MINERALS PROGRAM INSPECTION REPORT
PHONE: (303) 866-3567

MINE NAME: Tellier Gravel Pit	MINE/PROSPECTING ID#: M-1998-058	MINERAL: Sand and gravel and material for construc	COUNTY: Routt
INSPECTION TYPE: Monitoring	WEATHER: Clear	INSP. DATE: September 20, 2024	INSP. TIME: 08:00
OPERATOR: Oldcastle SW Group, Inc. dba United Compa	OPERATOR REPRESENTATIVE: Jesse Farmer	TYPE OF OPERATION: 112c - Construction Regular Operation	
REASON FOR INSPECTION: Normal I&E Program	BOND CALCULATION TYPE: None	BOND AMOUNT: \$104,116.00	
DATE OF COMPLAINT: NA	POST INSP. CONTACTS: None	JOINT INSP. AGENCY: None	
INSPECTOR(S): Brock Bowles	INSPECTOR'S SIGNATURE: 	SIGNATURE DATE: October 11, 2024

This inspection was conducted by Brock Bowles of the Division of Reclamation, Mining and Safety (Division). Jesse Farmer of United Companies (Operator) was present for the inspection. The Tellier Pit is located about 3 1/2 mile east of Milner. The site is a 112c operation with 25 acres permitted and the post-mining land use is pastureland. At the time of the inspection, it was warm, sunny and the ground was dry.

Photo 1 – Southwest corner of south pit, side slopes graded 3h:1v.

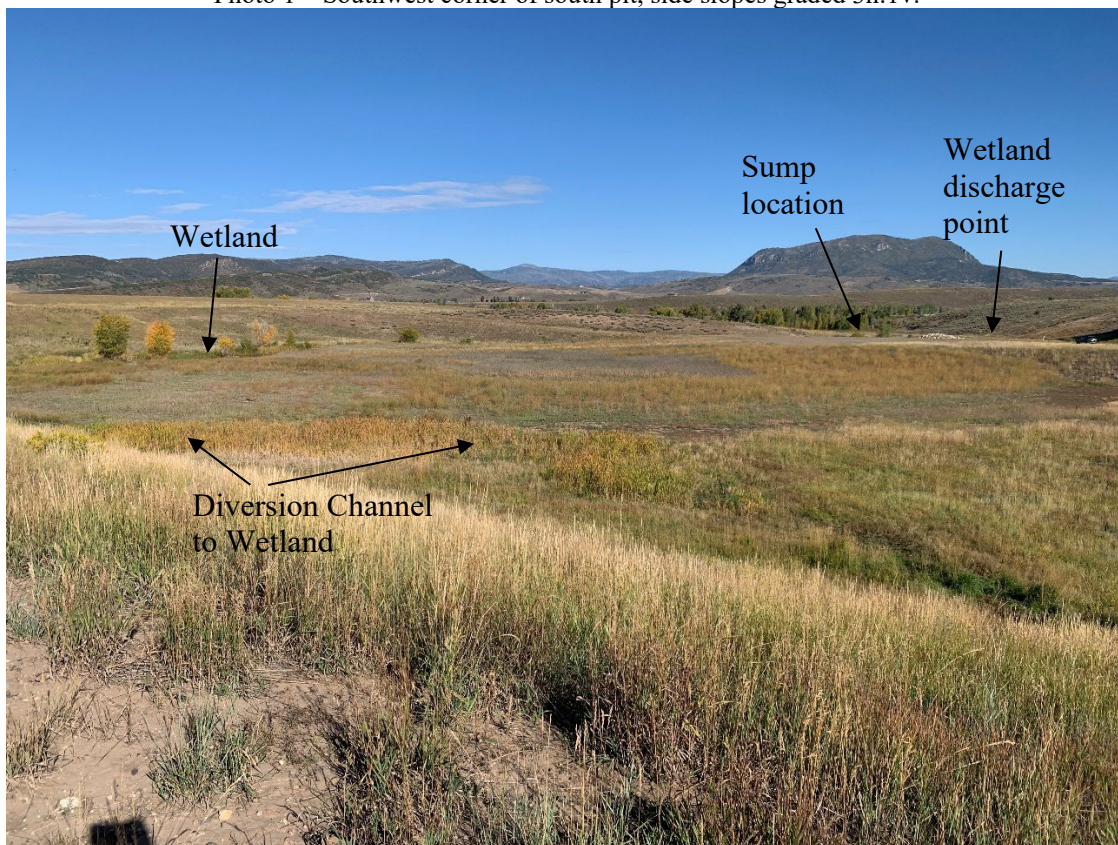
The pit consists of two main pit areas, a north pit and a south pit. The pits areas are separated by a 50-foot-wide gas line easement. The easement was not disturbed except the very east end where the pit access road crosses it. The slopes of the pit areas were graded 3h:1v on the west and south sides (photo 1). The sides of the gas line easement were also graded 3h:1v. No erosion features were noted in these areas.
